Service Bulletin

S.B. No: 143

FAIREY HYDRAULICS MAIN UNDERCARRIAGE BACKLASH CHECK

Issue 2 adds note to Para 1 and Fig 1 to hold torque links rigid.

Fig 1 PLACEMENT OF DIAL INDICATOR

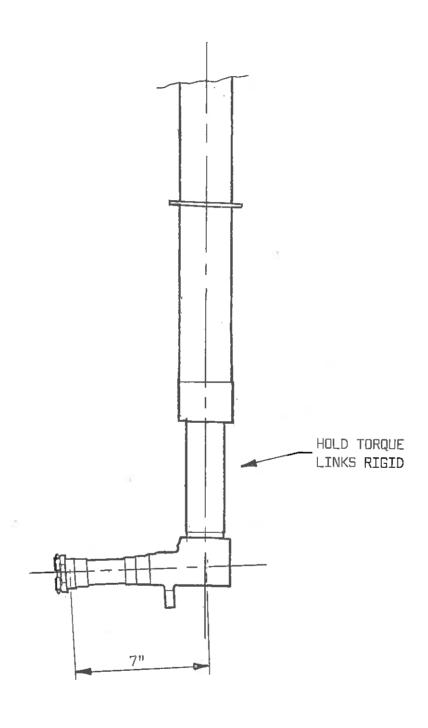
- 1. Support aircraft safely on jacks and remove main wheel and tyre assembly. Ensure torque links are held rigidly during loading.
- 2. Measure 7 ins along the stub axle from the centreline of the plunger tube. See Figure 1.
- 3. Set up dial indicator for up and down checks at the 7 ins position.
- 4. Establish a means to record the neutral position and zero the indicator.
- Apply 2 lbs of force upwards. Measure and record the deflection.
- 6. With stub axle back to the neutral position and indicator set to zero, apply 2 lbs of force downwards. Measure and record the deflection.
- Total deflection up and down must not exceed 0.020 ins.
- 8. Set up the equipment to record fore and aft deflections at the same 7 ins mark. Zero the indicator.
- 9. Apply 2 lbs of force forward. Measure and record the deflection.

- 10. With stub axle back to the neutral position and indicator set to zero, apply 2 lbs of force rearwards. Measure and record the deflection.
- 11. Total deflection forwards and rearwards must not exceed 0.040 inches.
- 12. If either of the requirements for maximum allowable deflection are not met, moving strut and stub assembly should be returned to manufacturer for inspection.
- 13. Annotate Log Book "SB 143 complied with"
- 14. The Maintenance Manual is in the process of being amended.
